Contract #: 04-0120F4Cty: SF/ALA Rte: 80 PM: 13.2/13.9File #: 69.25B**QUALITY ASSURANCE -- NON-CONFORMANCE REPORT****Location:** Changxing Island, Shanghai, PRC**Report No:** NCR-000173**Prime Contractor:** American Bridge/Fluor Enterprises, a JV**Date:** 08-Aug-2008**Submitting Contractor:** Zhenhua Port Machinery Company, Ltd (ZPMC), Changxing Island**NCR #:** ZPMC-0157**Type of problem:****Welding****Concrete****Other****Welding****Curing****Procedural****Bridge No:** 34-0006**Joint fit-up****Coating****Other****Component:** Tower Type 3B Diaphragm**Procedural****Procedural****Descriptor:** Tower Diaphragm ESD1-SA316 B/B**Reference Description:** 04-0120F4 Special Provisions**Description of Non-Conformance:**

Subject: NCR No. ZPMC-0157

Reference Description: Failure to follow Approved Procedure / Weld Sequence / Tower Diaphragm Assembly

PROJECT: SAN FRANCISCO OAKLAND BAY BRIDGE

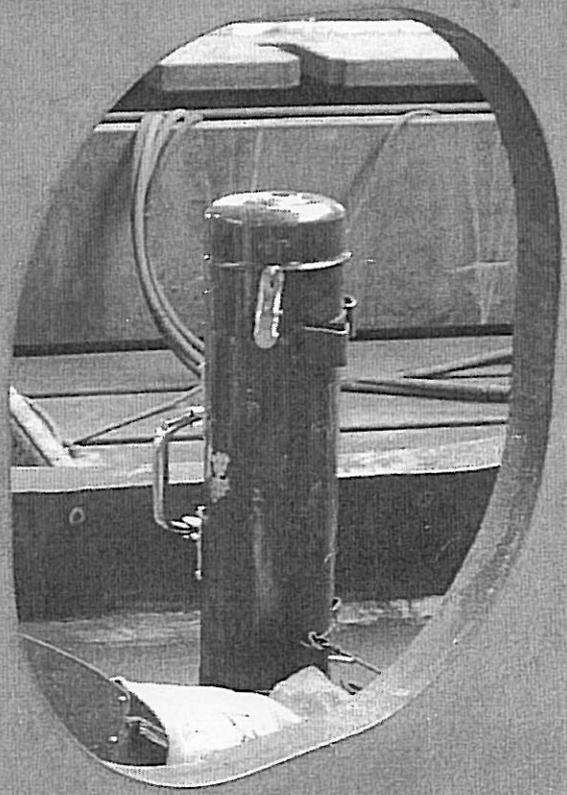
Project Name: S.F.O.B.B 项目名称: 美国加州海湾大桥		NCR Number: NCR 编号: NCR-T-009	
Item: welding web plates with diaphragm by the wrong sequence 名称描述: 未按制作工艺进行横隔板与腹板的焊接	Item Number: 件号: SA309	Drawing: 图号: ESD1-SA309	
Location: East Tower 28M Elevation Double Diaphragm 位置: 东塔 28M 双层隔板		Date: 2008-08-07 日期: 2008-08-07	
Description of Nonconformance: 不符合项状态描述: <p>AB/F 和加州监造发现 ZPMC 在实施东塔 28M 双层隔板与腹板焊接时未按制作流程操作。按照制作流程, 施工人员应当先完成双层隔板的装配, 并在装配尺寸确认无误的状态下进行焊缝焊接。但实际施工人员在双层隔板还未装配完成就进行了腹板与下层隔板的打底焊。因此违反了制作工艺。</p> <p>AB/F and Caltrans supervisors found ZPMC didn't follow the diaphragm fabrication procedure during welding the east tower 28M double diaphragm. According to the procedure, ZPMC should fit up the upper and lower diaphragm with web plates first. Then conduct the welding after the fitting dimension was checked. In fact, ZPMC gave the root pass between lower diaphragm and web plates before the top diaphragm fitted up.</p>

本按工艺要求逐行拼装。
zpmc didn't follow technology fabrication procedure.

严格按工艺要求逐行拼装。
Assemble and weld according to the technology procedure.

确保装配尺寸符合图纸要求, 可以回用。
The assembly size shall conform drawing requirement, and it can use as it is.

美国钢桥钢塔面板与面板、纵向筋、横隔板焊后检查记录卡
rib, diaphragm, skin plate checking after welding

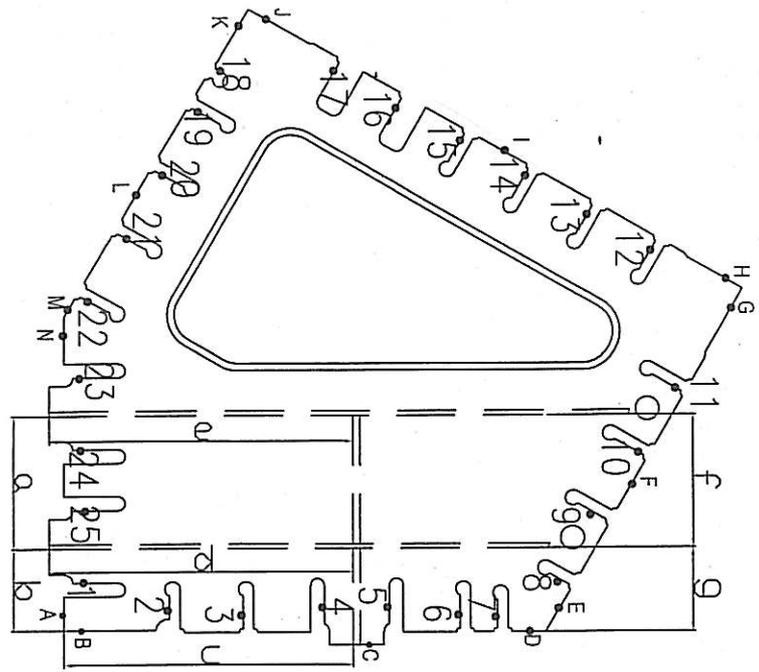
ZPMC acknowledged this nonconformance and issued out the internal NCR to prevent it from happening again. Due to the quick reaction, there was only around 1 or 2 root passes finished which did not result into the big effect to the deformation. The dimension checking report recorded the parameters after the double diaphragm welding finished.

The proposed resolution is acceptable. An internal Non-Conformance was written by ZPMC, and the attached documents show that the fit-up dimensions of the diaphragm are acceptable. The Department concurs that Non-Conformance ZPMC-0157 is closed.
